# PEER REVIEW OF SACRAMENTO VALLEY FINITE ELEMENT GROUNDWATER MODEL (SACFEM)

U.S. Bureau of Reclamation

Prepared by:  WRIME

October 2011

Figure 26. Net Stream Gain/Loss for Stony Creek below Black Butte Dam and Near Hamilton City

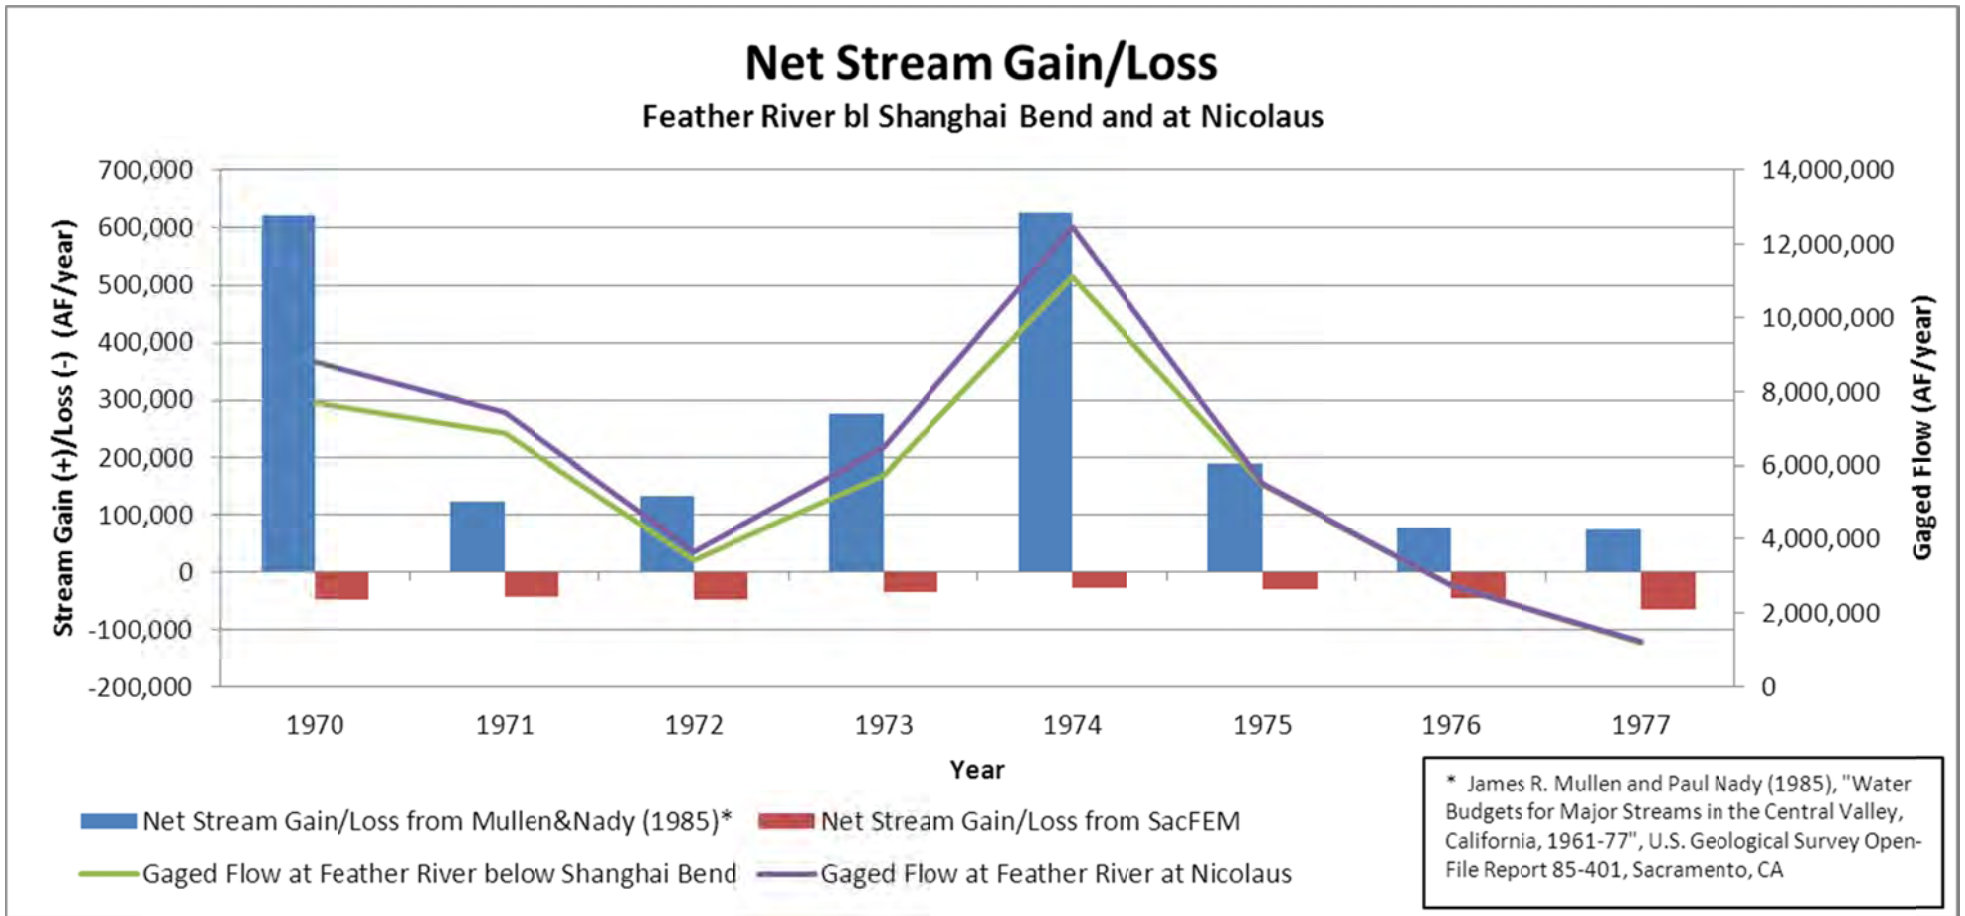
**Stony Creek** – Stream gains and losses for Stony Creek below Black Butte Dam are compared in Figure 26. The USGS study and SacFEM show that this is a losing stream year round; however, SacFEM losses are consistently overestimated. There were near zero flows in 1972 and 1976-1977, but SacFEM estimates of stream losses are highest for these years.

In the absence of stream stage data, adjustments of streambed resistances during the calibration process are used by some modeling efforts to fine tune the stream-aquifer interaction. However, for SacFEM the surface water stage fluctuations and groundwater level fluctuations are large enough to make a difference in stream gains and losses calculations and show that the assumption of constant stream stage is not valid. It is recommended that SacFEM use temporally varied stream stages on a monthly time step based on monthly streamflows. It is also recommended that the variable stream stages of regulated streams be revised for each SacFEM application scenario. Adjustment of streambed resistances may be used during SacFEM calibration after the stream stage data are incorporated in SacFEM input data files.

Figure 28. SacFEM Transient Calibration Scattergram from SacFEM Documentation (Lawson, 2009).

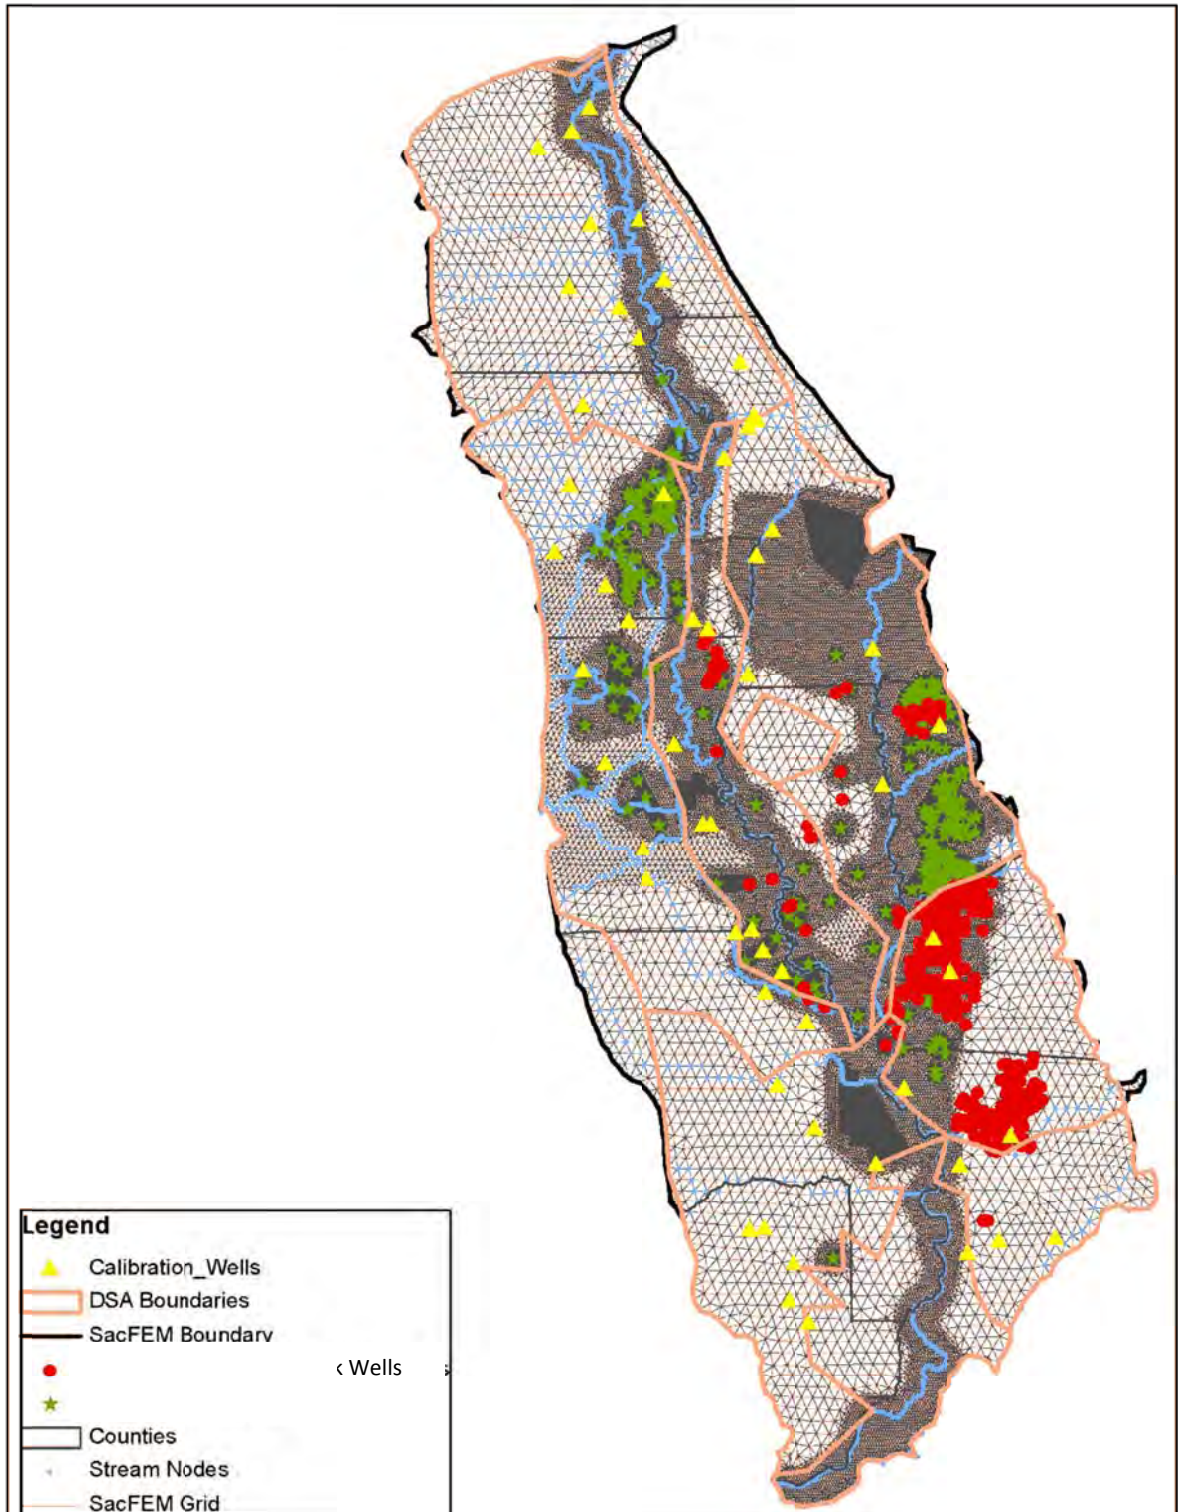
The matching status of the SacFEM calibration wells is provided in Table 5 and the scattergram of Figure 28. The long-term trend is not matched in twelve (12) out of the 41 long-term calibration wells. Seven (7) of the long-term calibration wells are in the vicinity of the urban areas of Sacramento, Woodland, and Chico.

Figure 31. Transient Calibration Hydrograph for Well 43  
(Layer 1) – Central Glenn County, West of Sacramento River  
(Blue markers and grey line represent observed and simulated groundwater elevations, respectively)

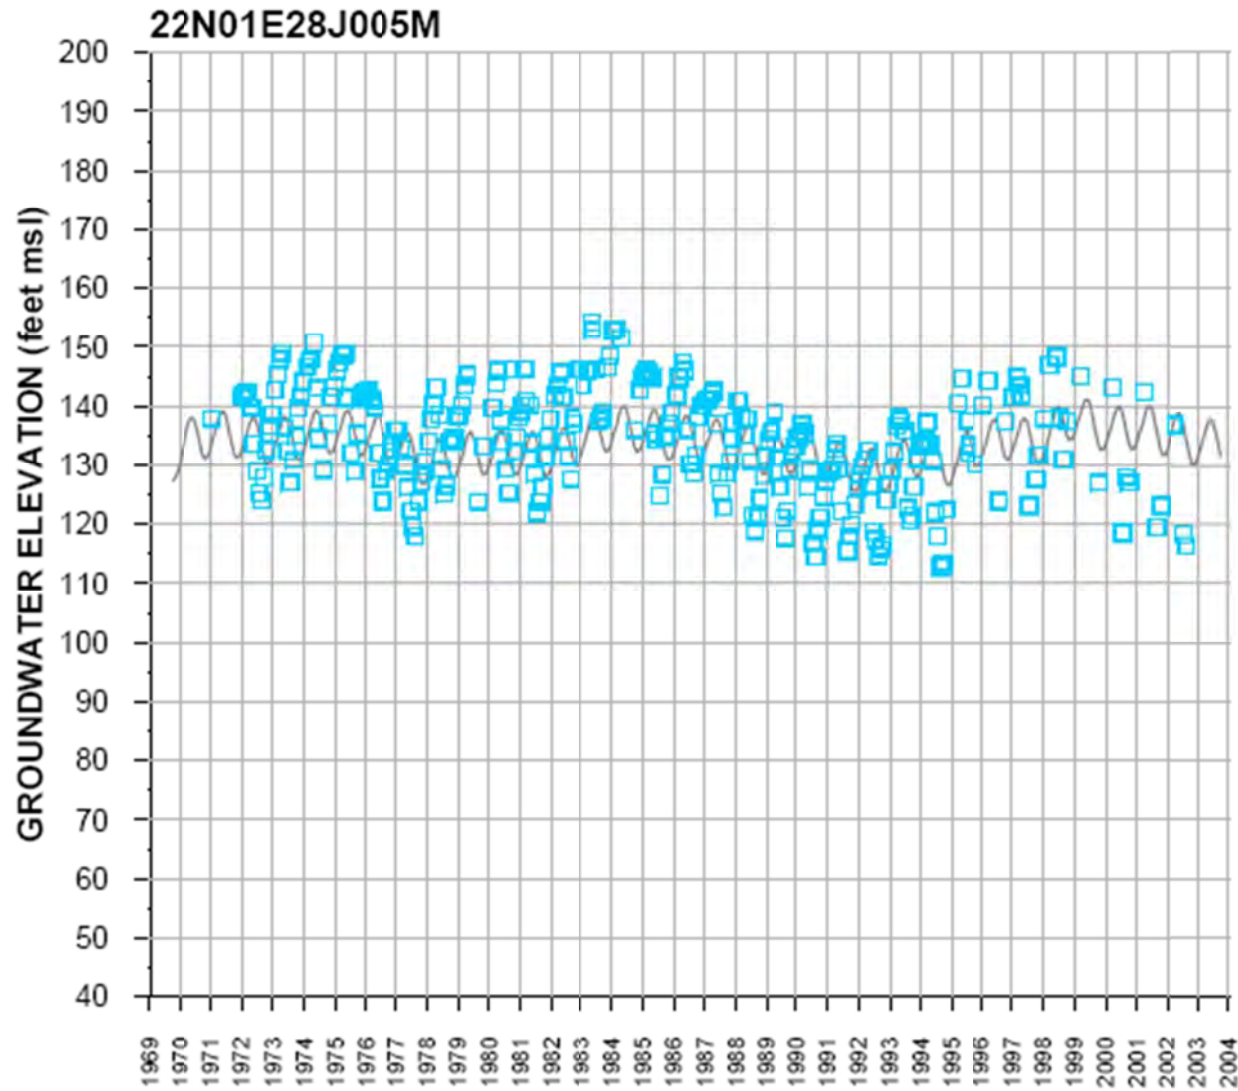
Simulated groundwater elevations for Calibration Well 43 are approximately 20 feet below observed groundwater elevations (Figure 31). This well is in an agricultural area with rice as the dominant crop. Water demand is met by surface water supply, with no groundwater pumping. High streambed resistances are used for nearby rivers and streams.

Figure 32. Transient Calibration Hydrograph for Well 40  
 (Layer 3) – Southern Glenn County, West of Sacramento River  
 (Blue markers and grey line represent observed and simulated groundwater elevations, respectively)

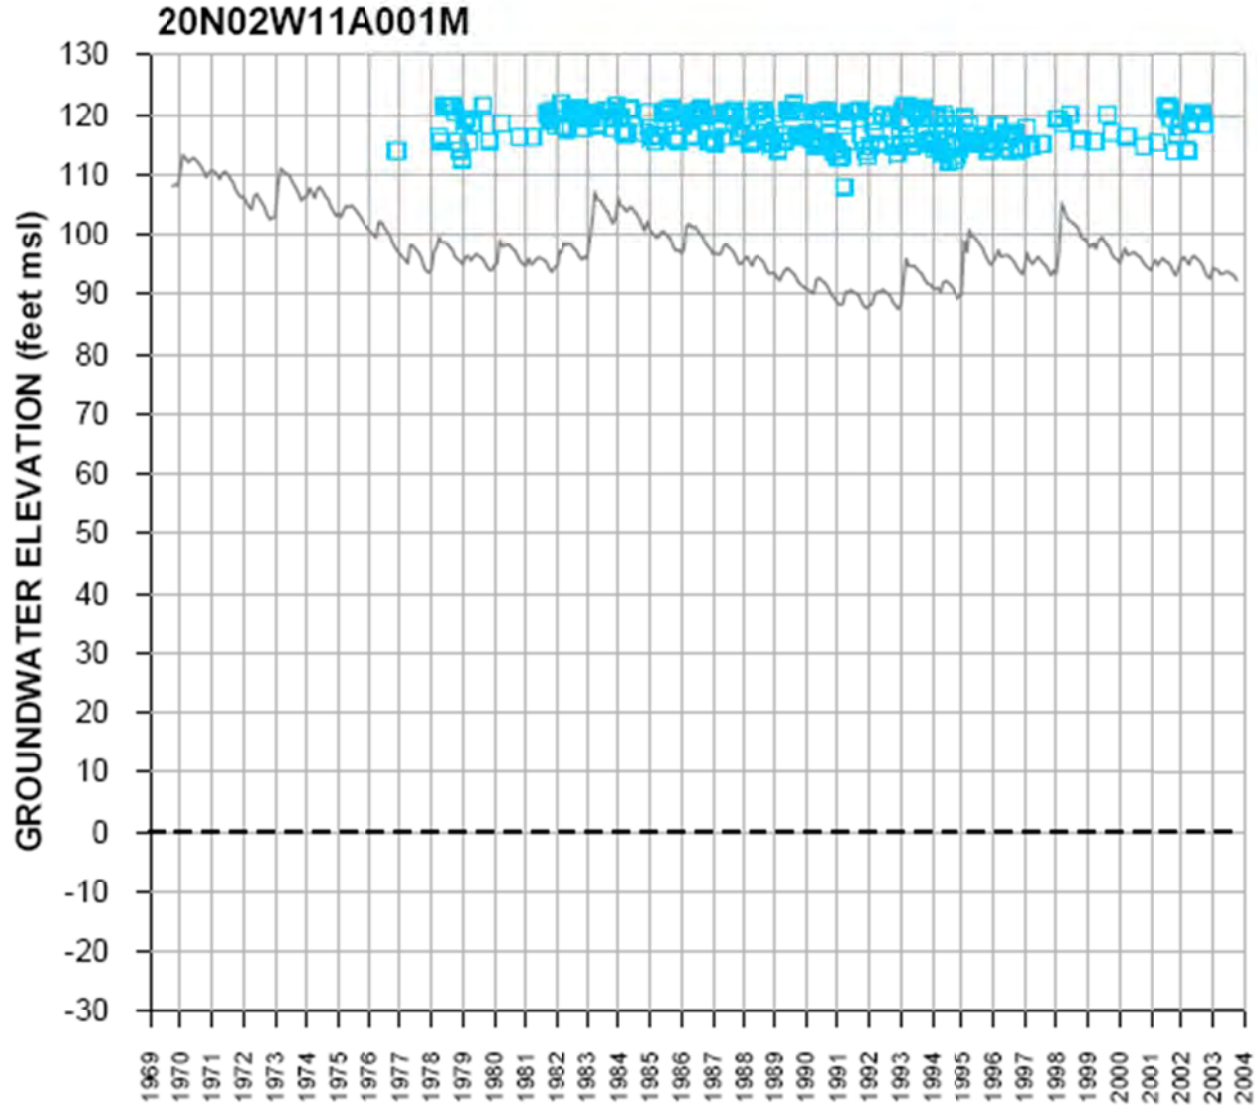
Calibration Well 40 has simulated groundwater elevations that are approximately 30 feet below the observed groundwater elevations (Figure 32). This well is also in an agricultural area with rice as the dominant crop. Water demand is met by surface water supply and low groundwater pumping. High streambed resistances are used for nearby rivers and streams.

Figure 33. Transient Calibration Hydrograph for Well 25  
 (Layer 2) – Southern Colusa County, West of Sacramento River  
 (Blue markers and grey line represent observed and simulated groundwater elevations, respectively)

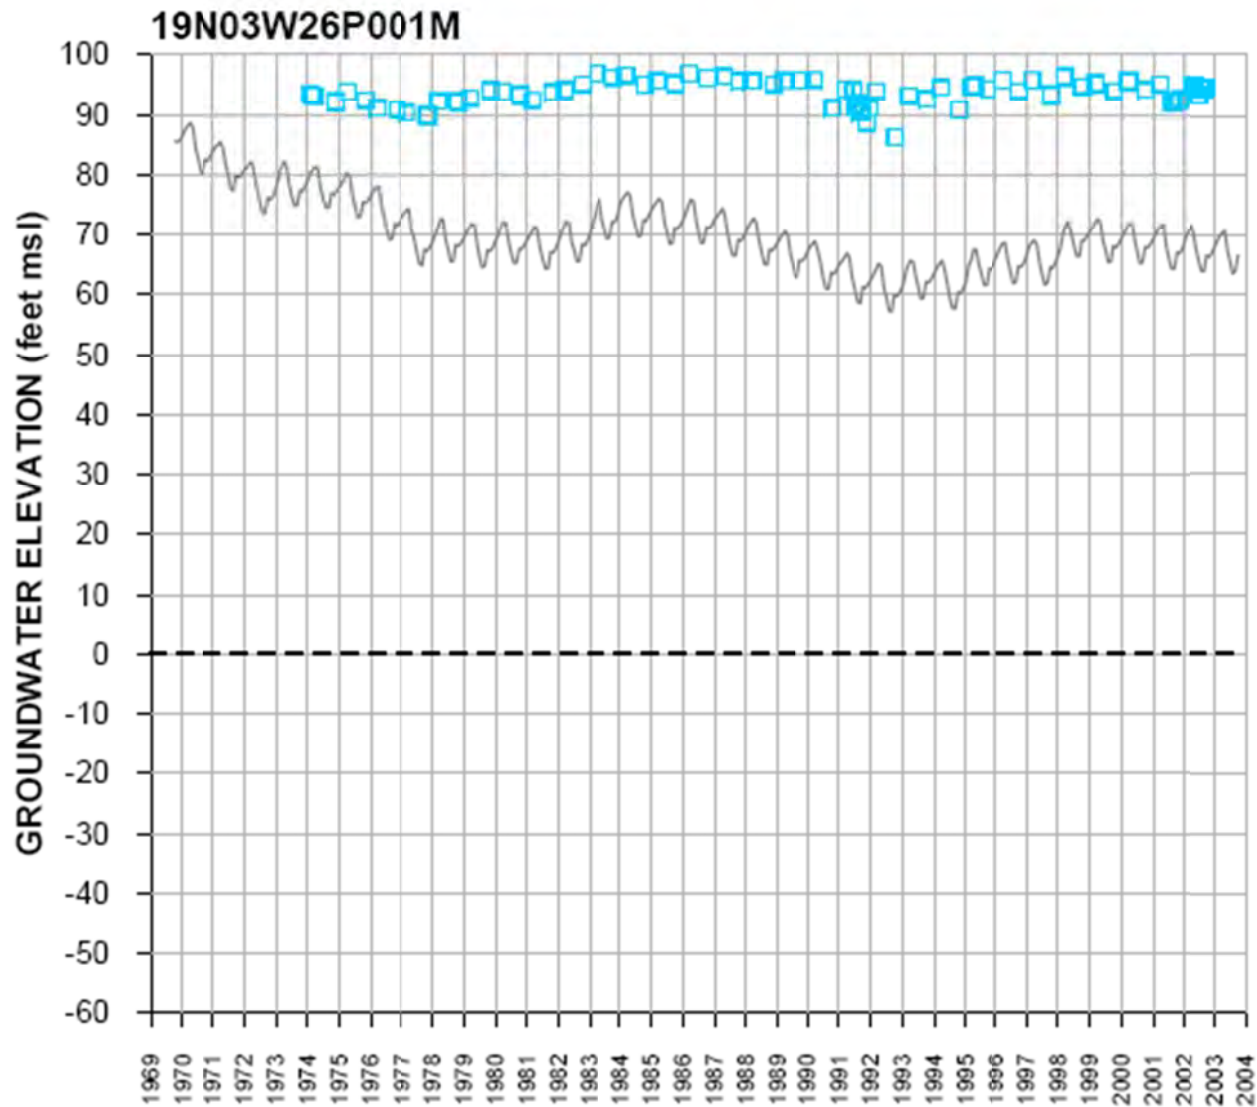
Recent trends in water levels are matched by Well 25; however, the simulated groundwater elevations are approximately 40 feet lower than the observed values (Figure 33). This well is in an agricultural area with orchards as the dominant crop. Water demand is met by surface water supply, with no groundwater pumping. Mixed streambed resistances are used for nearby rivers and streams.

Figure 35. Transient Calibration Hydrograph for Well 12  
 (Layer 1) – Central Sacramento County, North of American River  
 (Blue markers and grey line represent observed and simulated groundwater elevations, respectively)

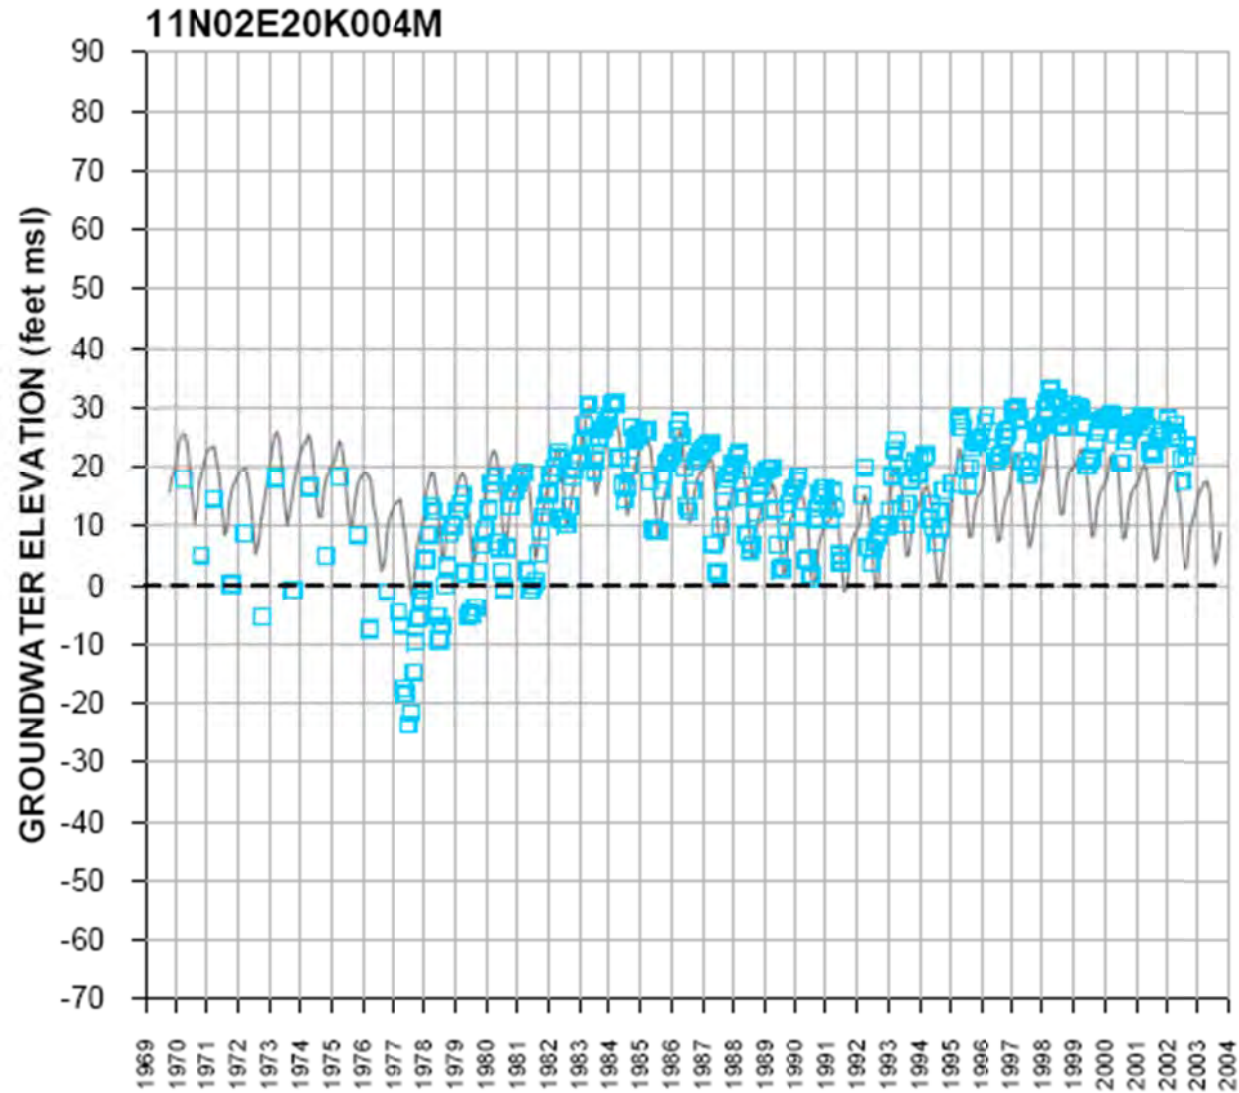
The long-term trend of observed groundwater elevations is not matched by Well 12 (Figure 35). Simulated groundwater elevations are approximately 40 feet higher than the observed values. This well is in the urban area of Sacramento. High streambed resistances are used for the nearby American River. Approximately 80,000 acre-feet of urban groundwater pumping in this area is not included in SacFEM. As a result groundwater levels are significantly higher than the observed values.
